PRELIMINARY/FINAL DRAINAGE REPORT

JUDGE ORR ROAD RV PARK & STORAGE DEVELOPMENT

**ADP Project No.160301
July 25, 2018**

PCD Project #PPR-16-040

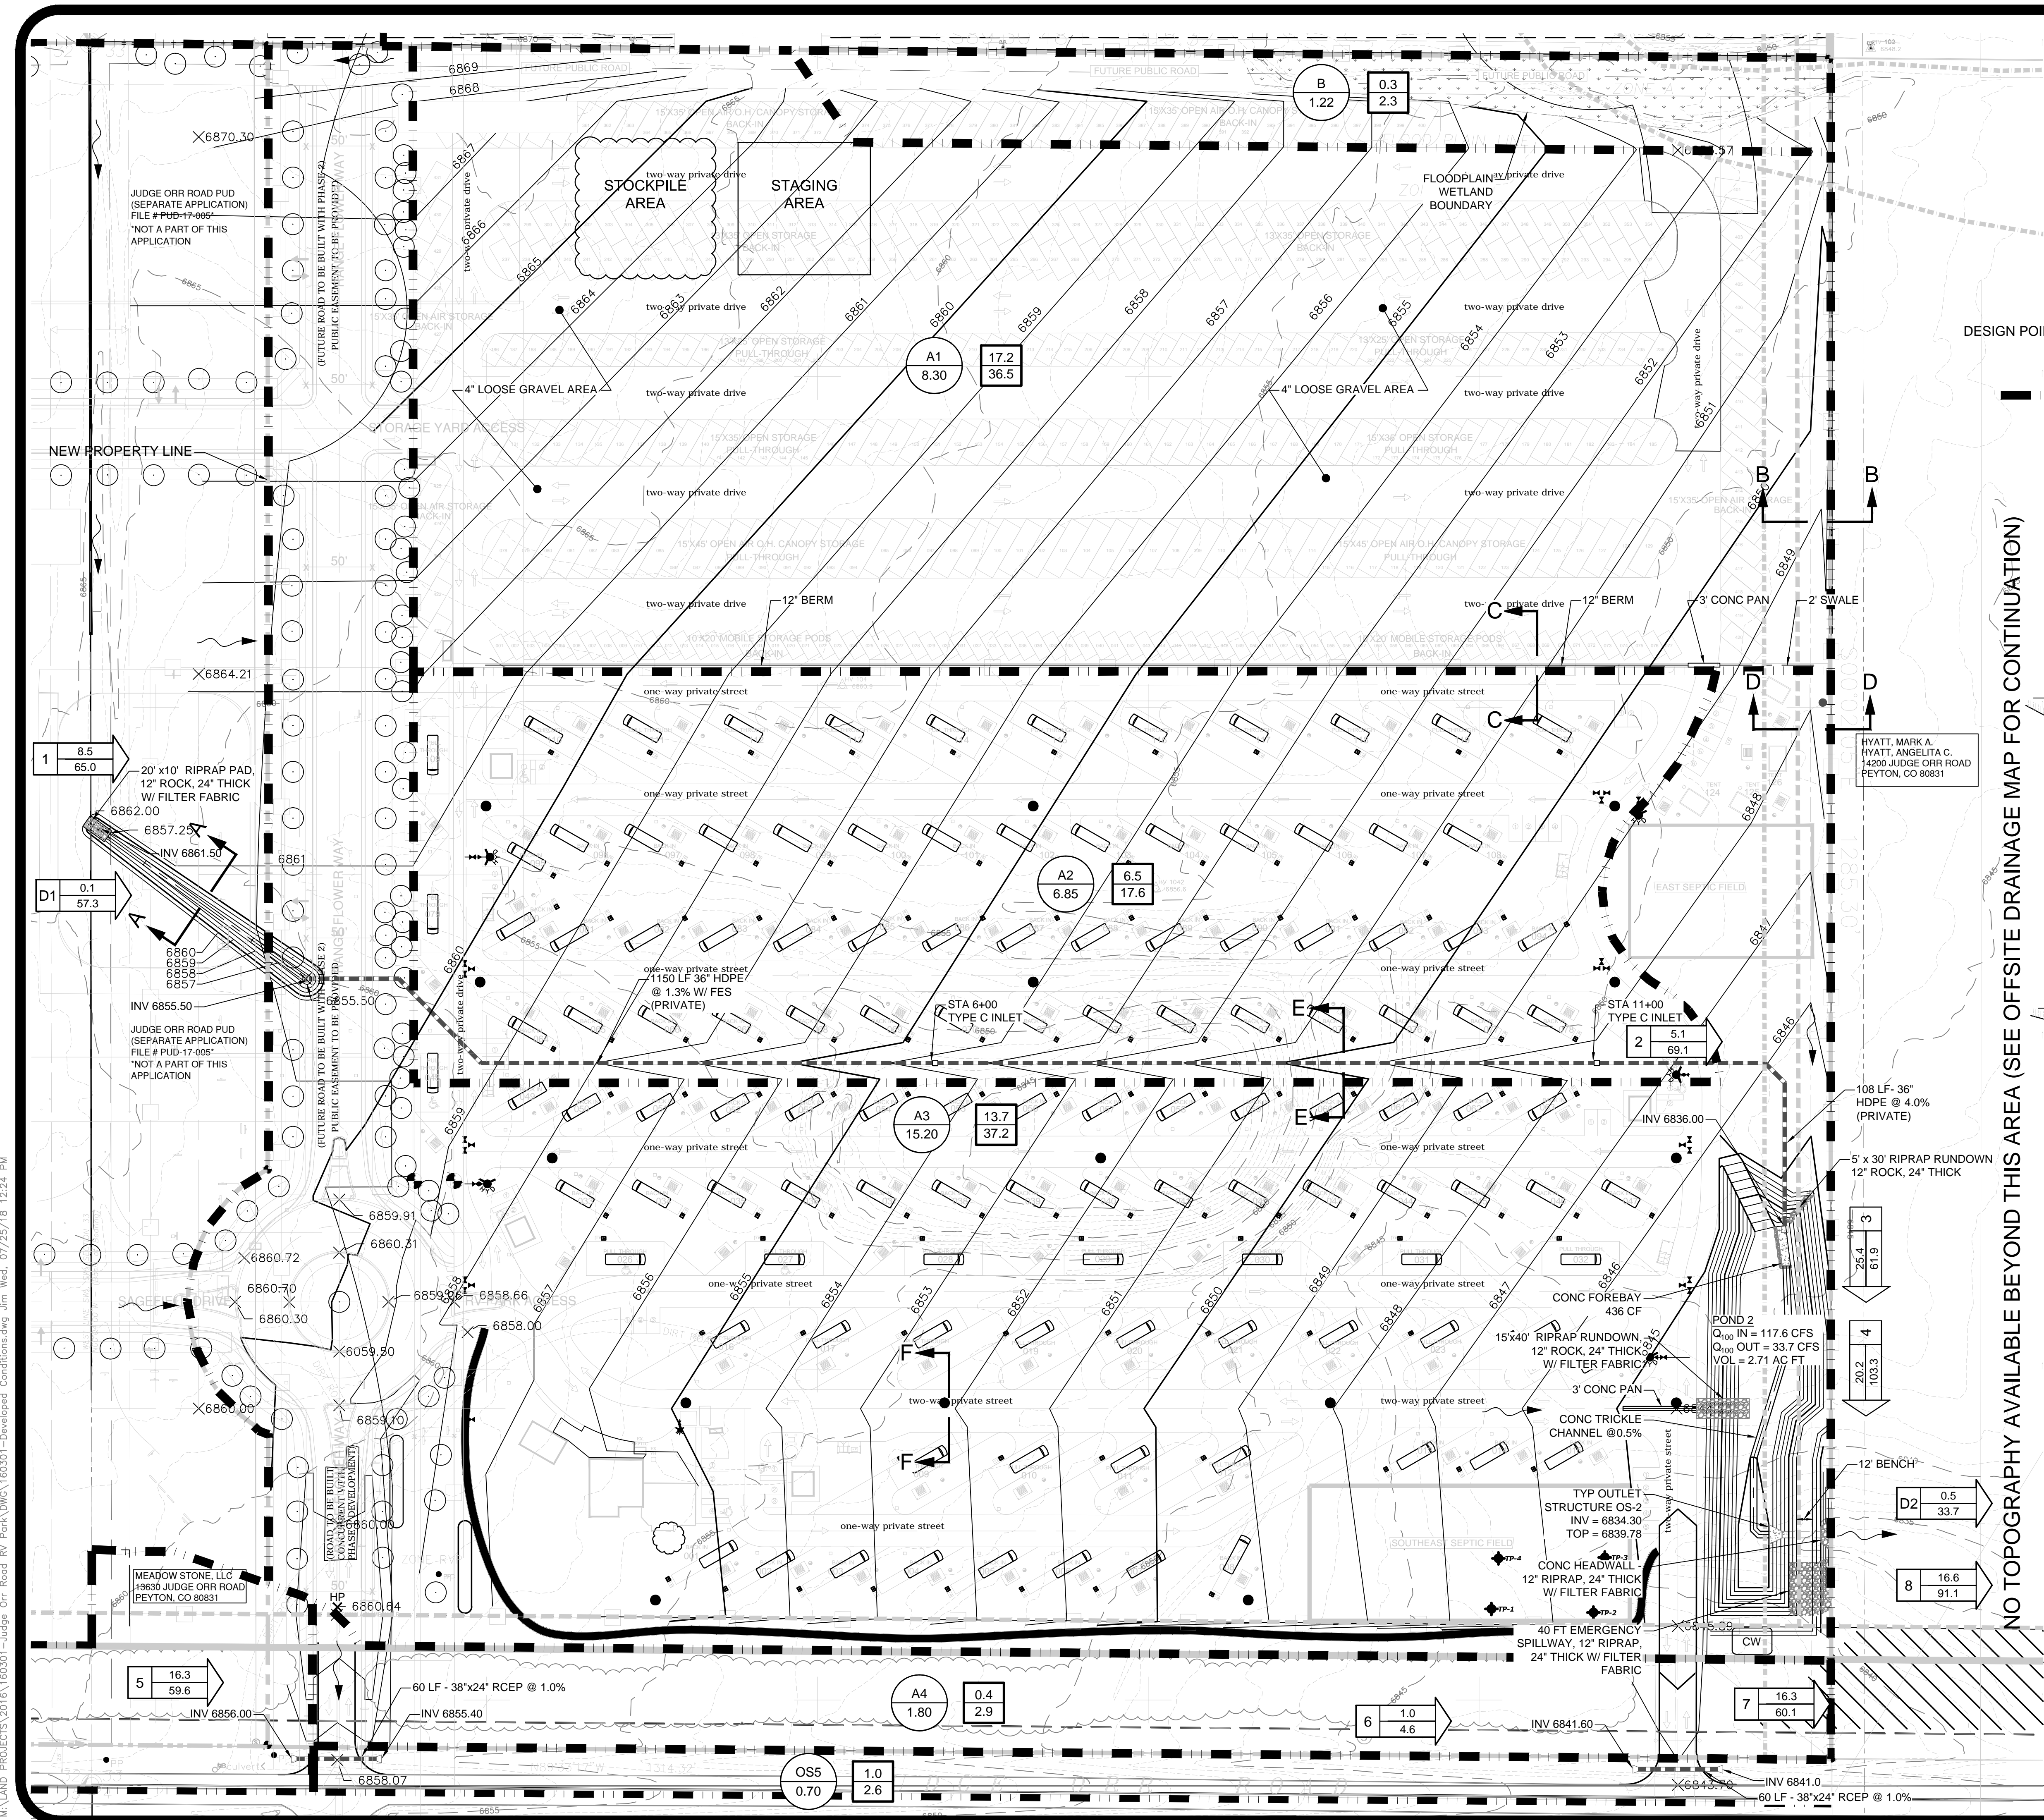
Analysis needs to extend to the swale. Looking at the contours the section highlighted in yellow does not appear to be hydraulically adequate and may need additional improvements.
